DELHI DEVELOPMENT AUTHORITY
(MASTER PLAN SECTION)
6th Floor, Vikas Minar, New Delhi.
Ph. No.23370507

No. F.1(02)2010-MP / 29

Minutes of the 1st Technical Committee meeting held on 15.01.2010.
List of the participants is annexed.

PROPOSED
220 KV. T/L
ROUTE NO.2

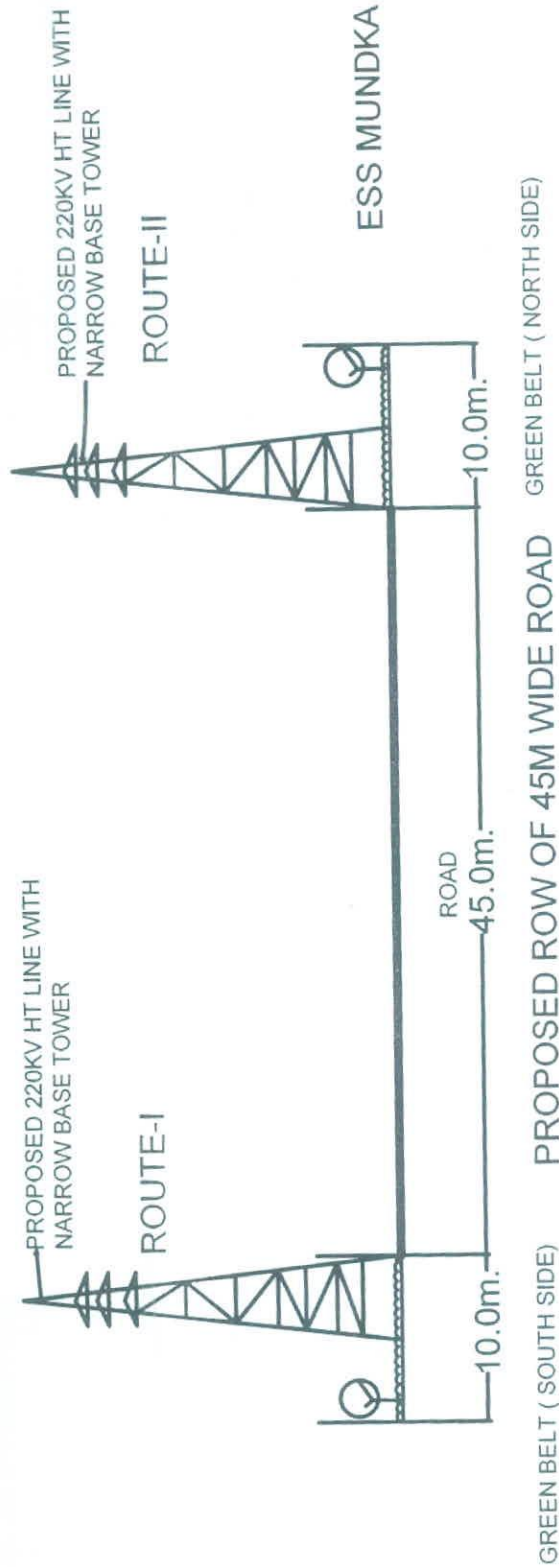
The sub group decided that precious land can be saved by using Multi- Circuit transmission line where each tower can hold four circuits. This will require only one right of Way. Further Land can be saved by use of Narrow base towers in place of wide base towers. Based on this the Delhi TRANSCO will submit the revised proposal for placing before Technical Committee for consideration.

The Delhi TRANSCO submitted the revised proposal in the office of Engineer Member which was discussed during the meeting with Engineer Member on 11.01.2010 where Commissioner (Plann.), Addl. Comm. (Plg)- III, Director Plg DWK were present. It was decided that decision of the Sub Committee and revised proposal submitted by Delhi TRANSCO to be placed before the Technical Committee for taking appropriate decision.
